Msgr. John N. Phuc Education Center  
Final Phase  
St. Charles Borromeo Church Parish  
13396 River Road  
Destrehan, LA

CD 1705

ADDENDUM #2      September 29, 2009

CAMPO DESIGNS – ARCHITECTS  
105 Ducaquet Drive  
Destrehan, Louisiana 70047

INTERIOR GRADE BEAM GB-2

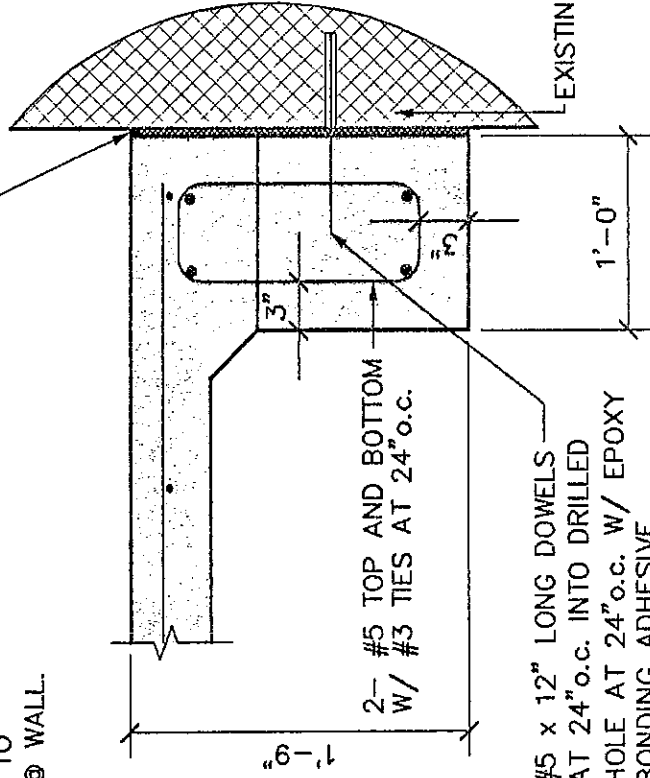
8. **Sheet S1.3 Structural Details;** Add the attached grade beam details, GB-1a, GB-1b, GB-2, and GB-2a.
